Product Change Notice: Product Marking Change of Select Inductors

PCN.PG27.12.29.2022

12.29.2022

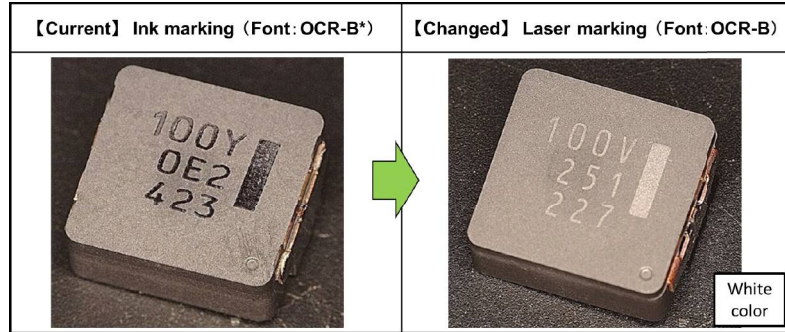
About This Notice:	Panasonic will change the Marking Method of select Inductors from “Ink Marking” to “Laser Marking”, which is already used for select parts of the ETQ-P series. All affected inductors marking method will change by 2024.
Effective Date:	For Tajima product : running change from May 2023 For Batam product : running change from November 2023
Change Details:	<p>Subject Part Numbers <MC-series></p> <ol style="list-style-type: none"> 1. Power Choke Coil for Automotive (MC type) 2. Power Choke Coil for Automotive-H (MC type) 3. High Vibration Acceleration-resistant Power Choke Coil for Automotive (MC type) 4. Hi Isat Power Choke Coil for Automotive (MC type) <p>Contents of Change</p> Change the marking method of the product display from "ink stamping method" to "laser printing method" (see below)
